CITY OF ST. HELENS PLANNING DEPARTMENT

MEMORANDUM

FROM: Jennifer Dimsho, AICP, Associate Planner **RE:** 270 Strand Street (Columbia View Park)

DATE: December 30, 2022

SHEET TITLE STAGE EXTERIOR ELEVATIONS AND SECTION

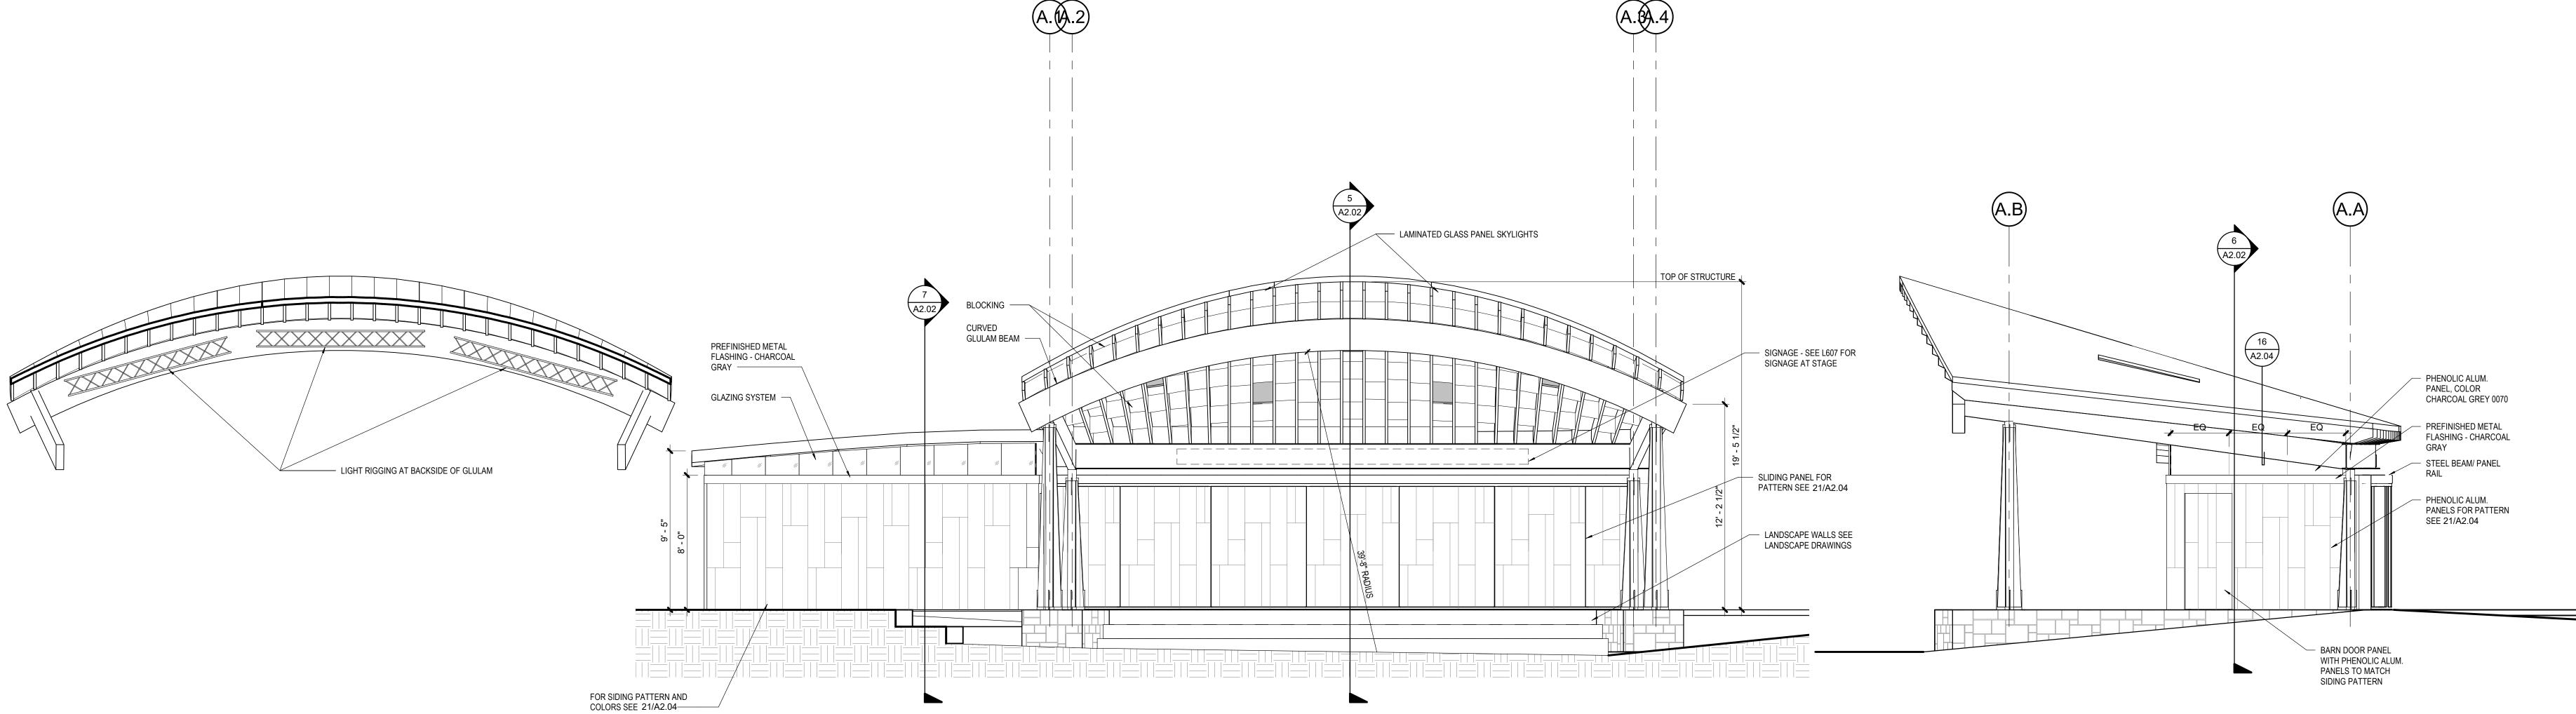
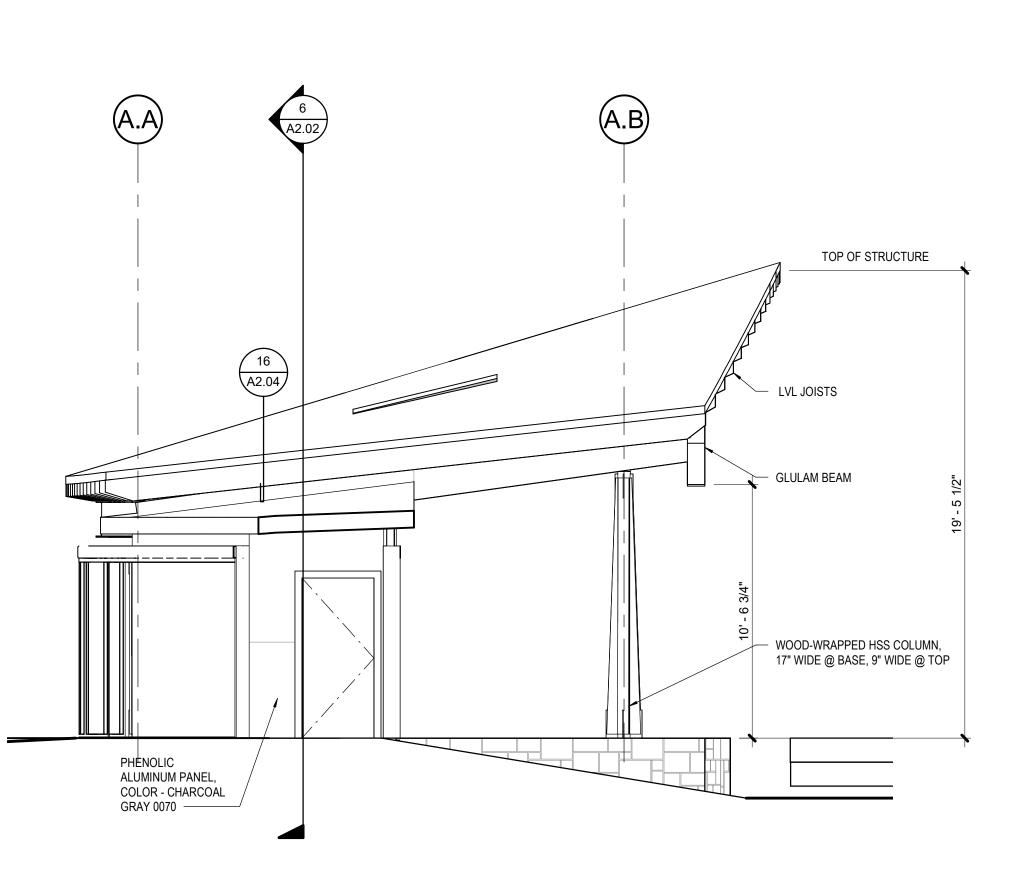
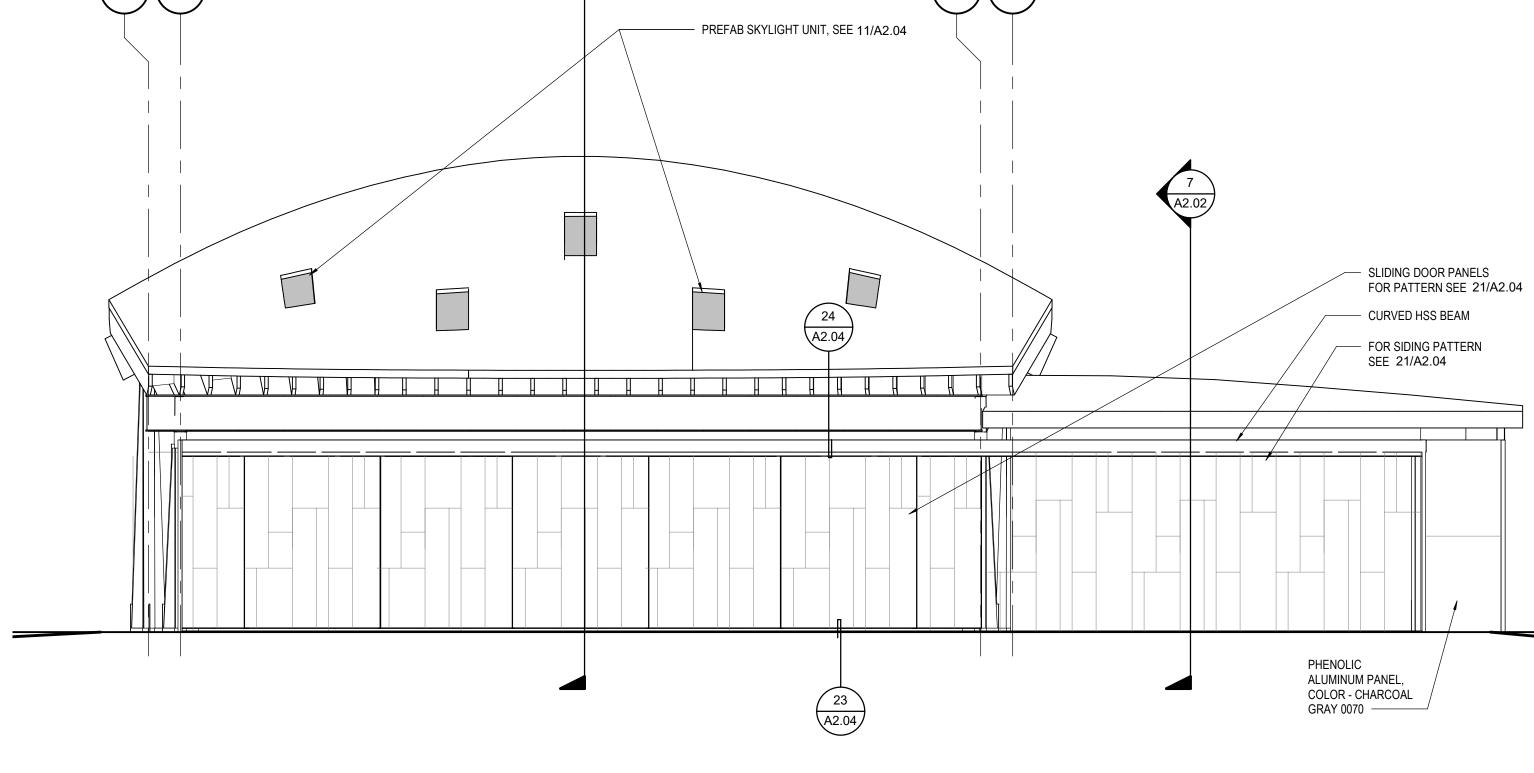
Stage/Storage Staff Comments: Overall, the Guidelines are focused on consistency with surrounding mixed-use development. The stage is adjacent to the historic basalt Columbia County courthouse building. There are aspects of the design which incorporate basalt blocks including the stacked seatwalls just behind the dance floor and the basalt stone veneer around the sides of the stage. To help blend the old with the new, the stacked stone seatwalls are also similar in design to the existing stacked stone amphitheater seating which are remaining in the park. The other relevant section of the Guidelines which staff feels applies to the stage is the Material and Building Colors section on Pages 15 and 16.

Does the Commission feel like the design of the stage is consistent with the Guidelines when it comes to the color pallet of the sliding stage panels and the storage building siding?

PAVILION PLANS AND

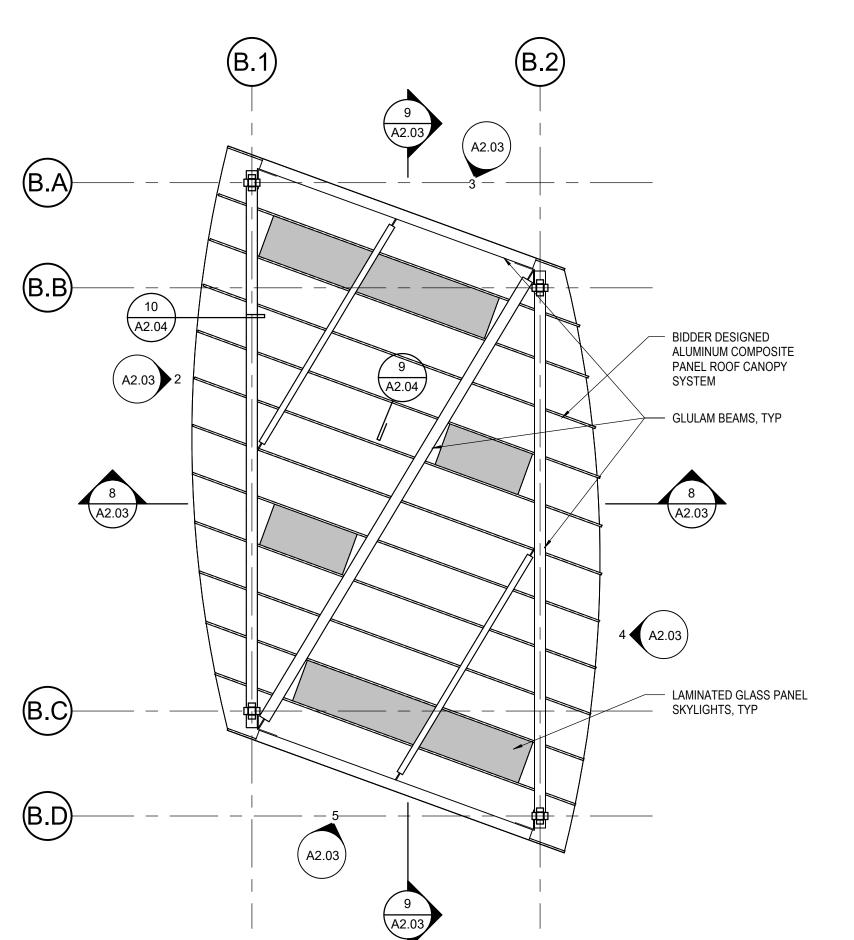
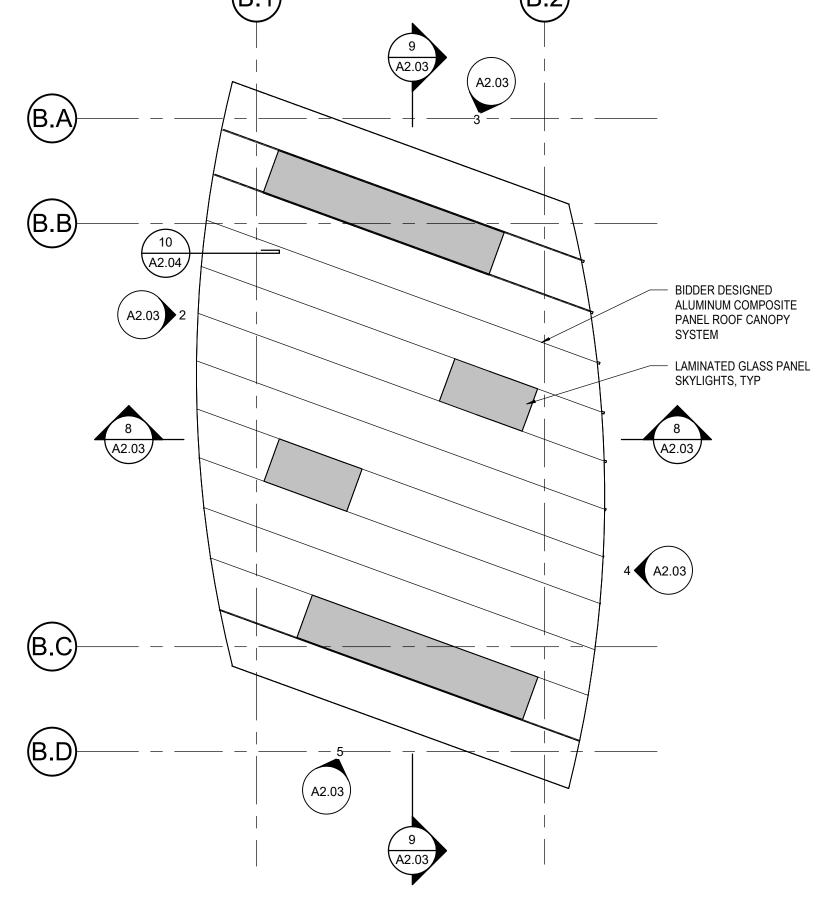
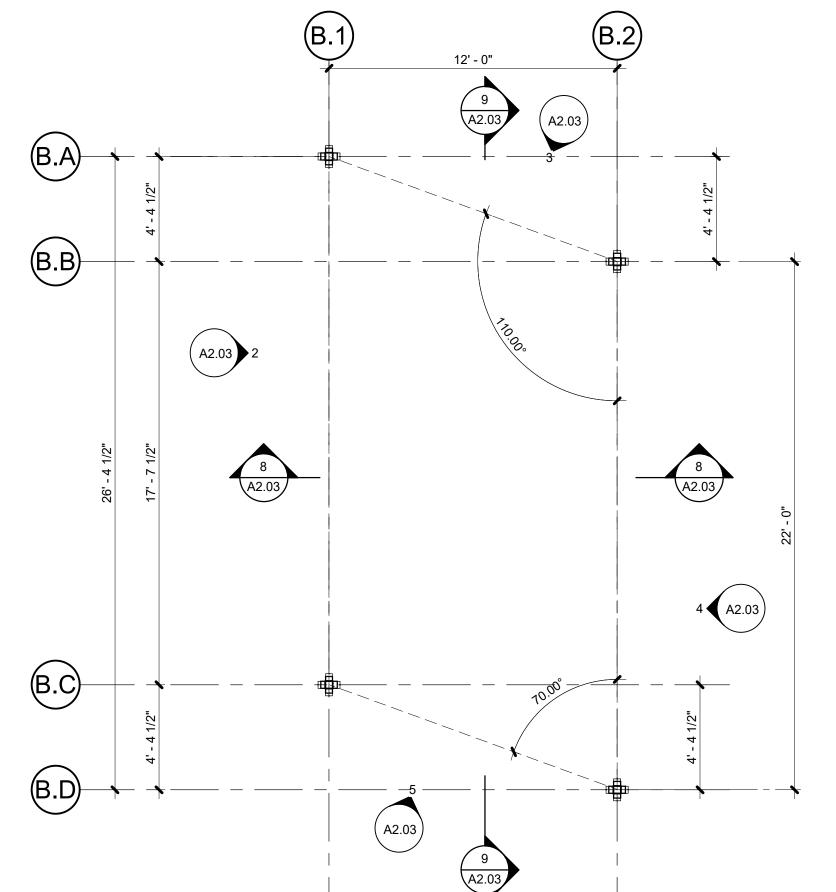
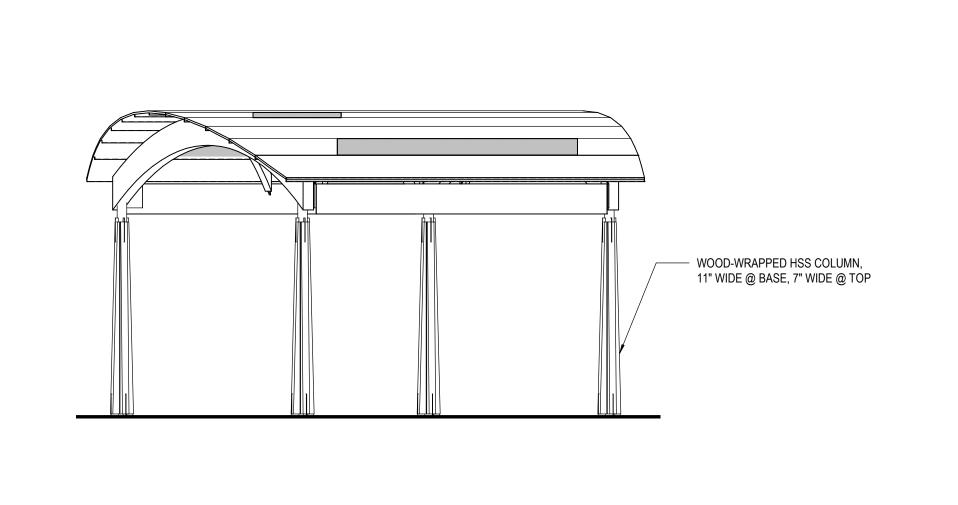
<u>Pavilion Staff Comments</u>: Staff does not see any inconsistency with the Guidelines as applied to the pavilion. Does the Commission have any thoughts or concerns with the pavilion design as it relates to the Guidelines?

STAGE - CONTEXT ELEVATION SCALE: 1/4"= 1'- 0"

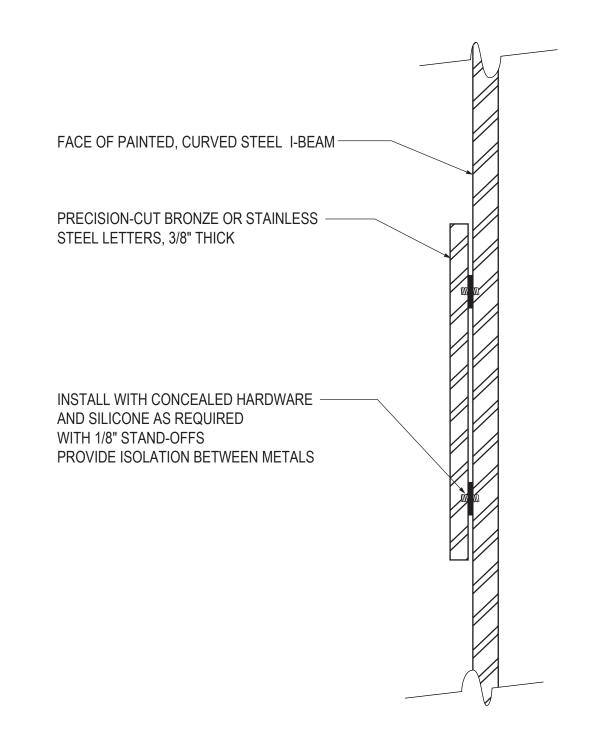
<u>Wall Sign Staff Comments</u>: For new signage construction, the Guidelines state that metal is an appropriate material. The proposed sign has a simple lettering style which is proportional to the stage and easy to read. This is consistent with the Guidelines. <u>Does the Commission agree?</u>
